ADDENDUM NO. ONE (1)

PROJECT NO: 1210843

Natural Playscape

Lake Corpus Christi State Park, San Patricio County Texas

FALLEN CLIMBING TREE

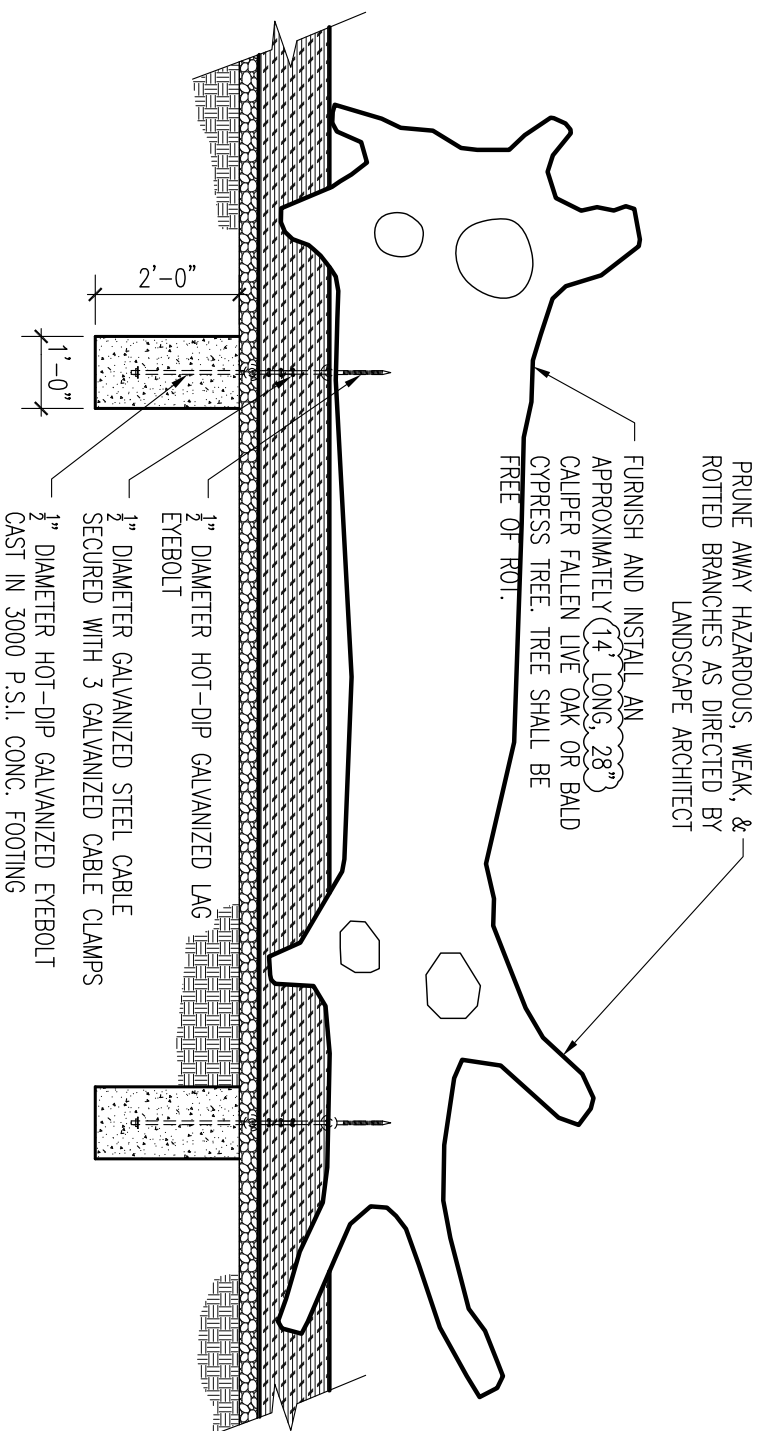
1. On Detail 3 of Drawing Sheet L3 the size of the Fallen Climbing Tree has been revised to be 14' long, 28" caliper.
2. The attached Drawing addition is hereby incorporated into the referenced solicitation issued on January 28, 2021.
